CITY OF ALBUQUERQUE

**RE: Capra Bank Albuquerque
5171 Lang Ave. NE
Grading and Drainage Plan
Engineer's Stamp Date: 07/26/2025
Hydrology File: D17D106D
Case # HYDR-2025-00337**

Based upon the information provided in your submittal received 09/19/2025, the Grading & Drainage Plans are not approved for Building Permit. The following comments need to be addressed for approval of the above referenced project:

GRADING, PAVING AND DRAINAGE PLAN - PHASE 1 BUILDING
C-400

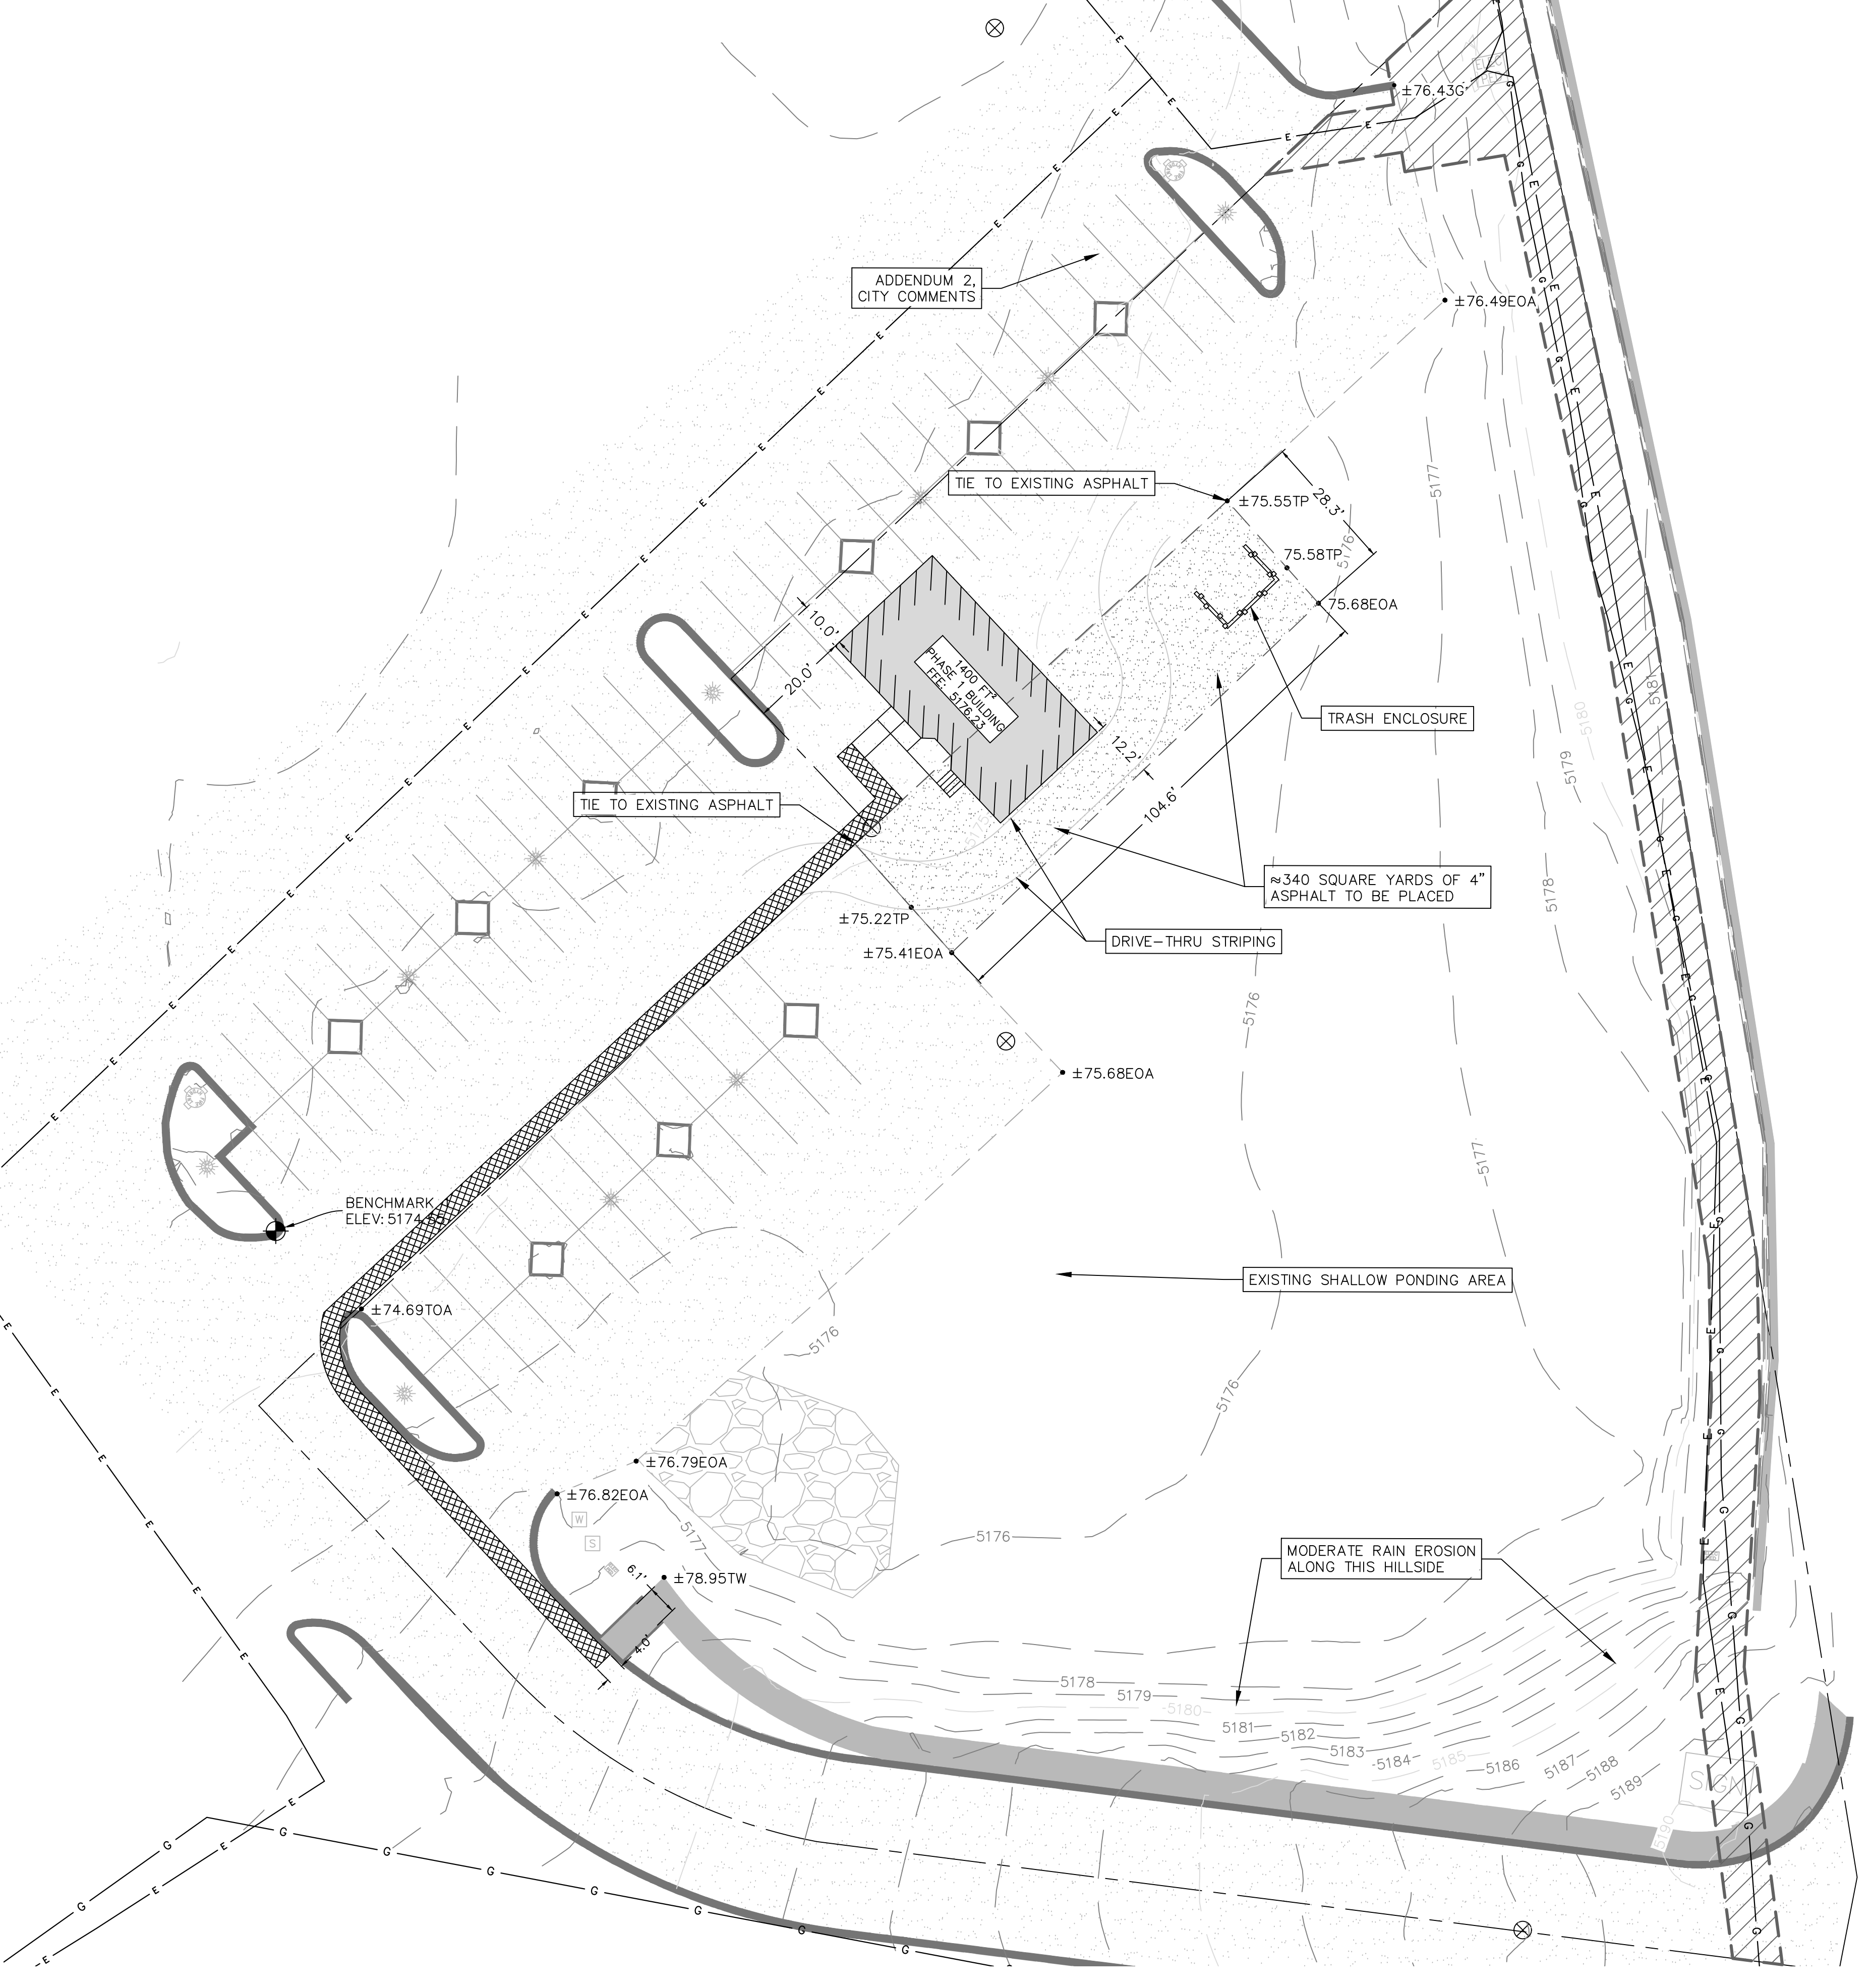
1. Per the [DPM](#), the following must be on the Grading Plan. Please note the Grading Plan must be a stand-alone construction document:
 - Please use 1" = 20' for the scale. (This may make two sheets)

- Please provide a Vicinity Map. This can be downloaded in pdf format from the City of Albuquerque's website.
 - Please provide the Benchmark information (location, description and elevation) for the survey contour information provided.

- Please provide the FIRM Map and flood plain note with effective date.
 - Please provide a legal Description of the property.
2. Please add a note under Grading Notes. "Side slopes need to be stabilized with Native Grass Seed (per City Spec 1012) with Aggregate Mulch or equal (Must satisfy the "Final Stabilization criteria" CGP 2.2.14.b.)".

3. Provide management onsite for the Stormwater Quality Volume (SWQV) in accordance with the new drainage ordinance, § 14-5-2-6 (H). Please show the top and bottom of the ponds along with the volume for each pond. The onsite drainage should be directed to these ponds prior to being collected in a private unground drainage system. Please follow the DPM Article 6-12 Stormwater Quality and Low-Impact Development for the sizing calculations. To calculate the required SWQV, multiply the impervious area draining to the BMP by 0.42 inches for new development sites and 0.26 inches for redevelopment sites. The calculations of both the required and the provided volume of

each BMP must be shown on the Grading and Drainage Plan. Each BMP should be labeled on the Grading and Drainage Plan with the required SWQV and associated water surface elevation and the 100-year water surface elevation. Landscaping of surface BMPs is also required to be noted on the Grading and Drainage Plan.

4. Please number the ponds and include a label on each with the SWQV and elevation, the 100-year volume and elevation, the peak 100 year inflow and outflow, the spillway crest elevation, the spillway flow depth, and the dam top elevation.

5. Please provide the SWQV calculations for each basin draining to each pond. The stormwater quality ponds need to be sized for the areas draining to them.

8. Please add a note which states, "The Owner has elected to pay the Payment in Lieu for the required Stormwater Quality Volume.
 9. Show the payment calculation on the plan: Example - Payment in Lieu (Amount = 207CF x \$8/CF = \$1656, per sheet C-002) of onsite management of the SWQV.
